Title	:	Pre Bid Clarifications - IV
EMPLOYER	:	REC Transmission Projects Company Limited
Project	:	Design, Manufacturing, Supply, Erection, Testing & Commissioning of 160 MVA, 220/33-33 kV Gas Insulated Substation (GIS) at Lassipora on Turnkey Basis associated with Strengthening of Transmission System of JKPDD under PMDP Scheme-15".
Tender Specification No.	:	RECTPCL/PIA/JKPDD/SS -02
e-Tender Event No-	:	RECTPCL/17-18/ET/7 [137037]

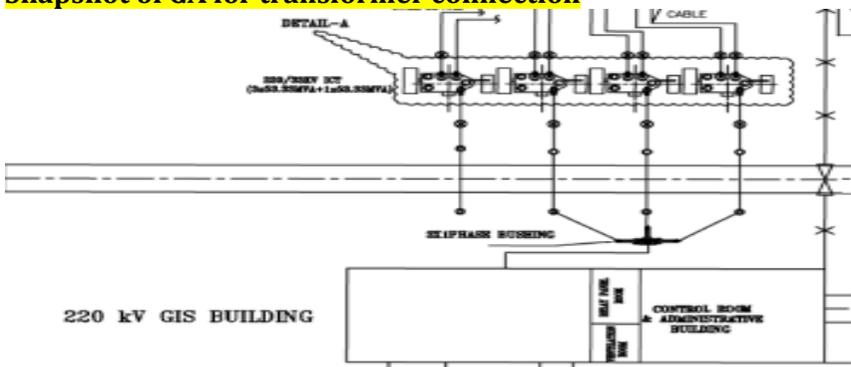
SL. NO.	CLAUSE / DWG NO.	REFERENCE / EXISTING CLAUSE	QUERY DESCRIPTION	Employer's Reply
		Company or a Joint Venture Company as per the provision of bid document. (iii) Sixty (60) months for (132kV/220kV/400kV Class) Transformer from the date of Taking Over/Completion of Facilities (or part thereof). For the purpose of this clause, the Measurable Defects as per the Technical Specifications shall also be considered for Transformer. (iv) Twelve (12) months from the date of Taking Over/Completion of Facilities for all equipment/materials other than those specified at (i), (ii) and (iii) above".
